Project	IEEE 802.16 Broadband Wireless Access Working Group < http://ieee802.org/16 >	
Title	A Key Management Method for the Multicast Service	
Data Submitted	2004-03-16	
Source(s)	Seokheon Cho Ae Soon Park Chulsik Yoon SungCheol Chang Kyung Soo Kim	Voice: +82-42-860-5524 Fax: +82-42-861-1966 chosh@etri.re.kr aspark@etri.re.kr
	ETRI 161, Gajeong-dong, Yuseong-Gu, Daejeon, 305-350, Korea	
Re:	This is a response to a Ballot #14 Announcement IEEE 802.16-04/06 on IEEE P802.16e-D1.	
Abstract	The document contains suggestions on the changes in IEEE P802.16e-D1 that would support efficient key management method for the multicast service.	
Purpose	The document is submitted for review by 802.16 Working Group members.	
Notice	This document has been prepared to assist IEEE 802.16. It is offered as a basis for discussion and is not binding on the contributing individual(s) or organization(s). The material in this document is subject to change in form and content after further study. The contributor(s) reserve(s) the right to add, amend or withdraw material contained herein.

A Key Management Method for the Multicast Service
Seokheon Cho, Ae Soon Park, Chulsik Yoon, SungCheol Chang, and Kyung S

Figure 127 - TEK state machine flow diagram

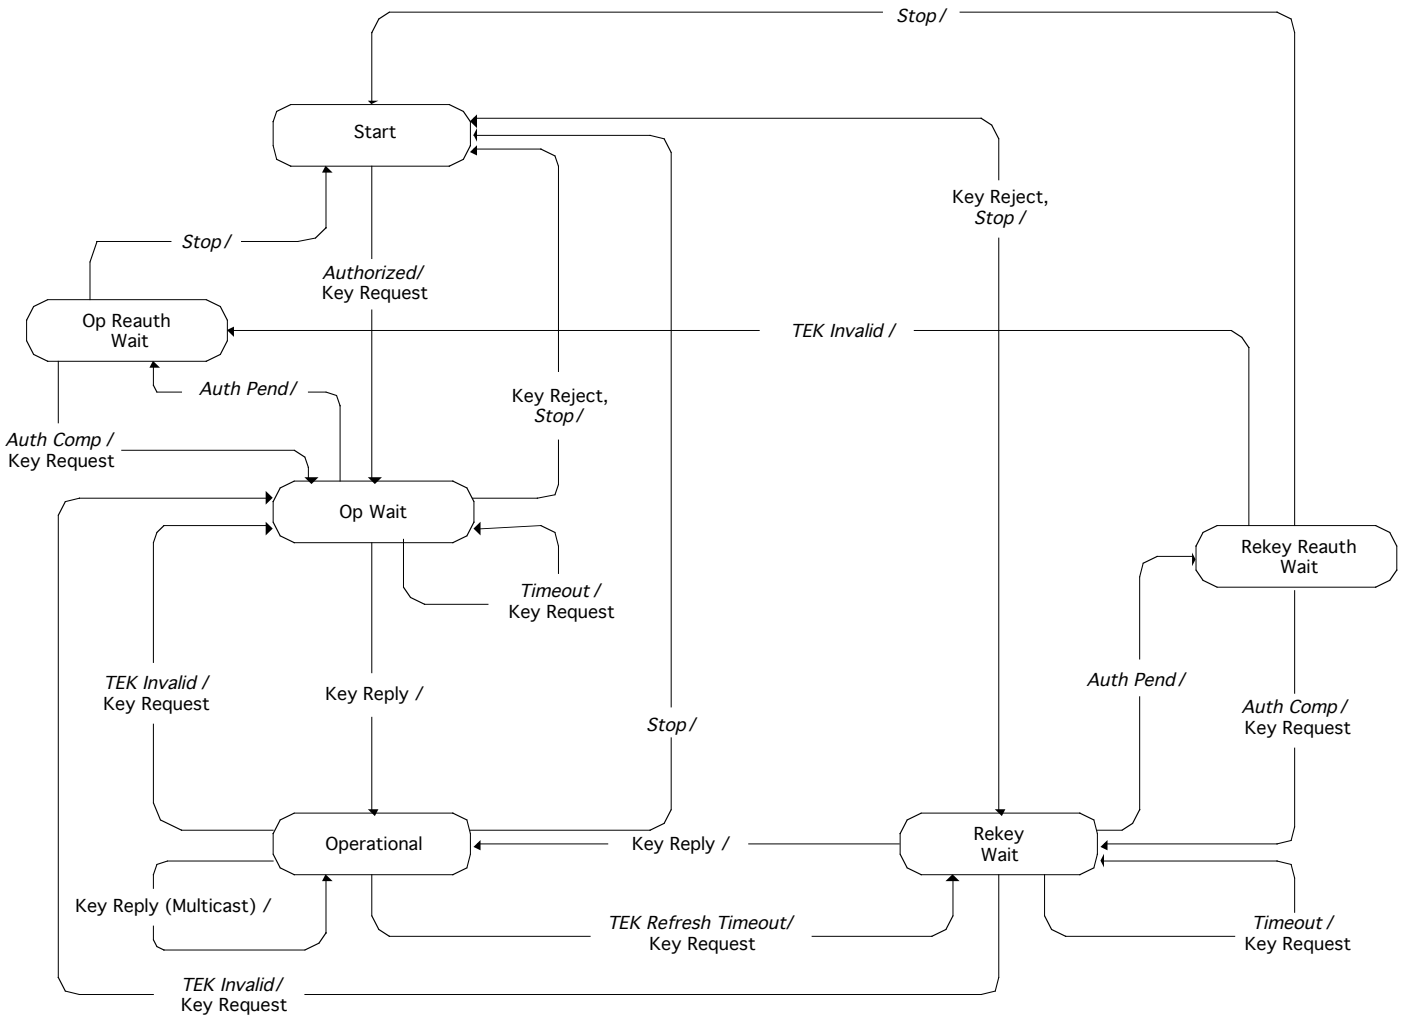
[Change the Figure 127]

NOTE: The state, Operational (D), can be transited to the “Operational” state by receiving the Key Reply message for the multicast transport service such as “8-D”.

8-D Operational (Key Reply: Multicast) → Operational

- process contents of Key Reply message and incorporate new keying material into key database
- set the TEK refresh timer to go off “TEK Grace Time” seconds prior to the key’s scheduled expiration
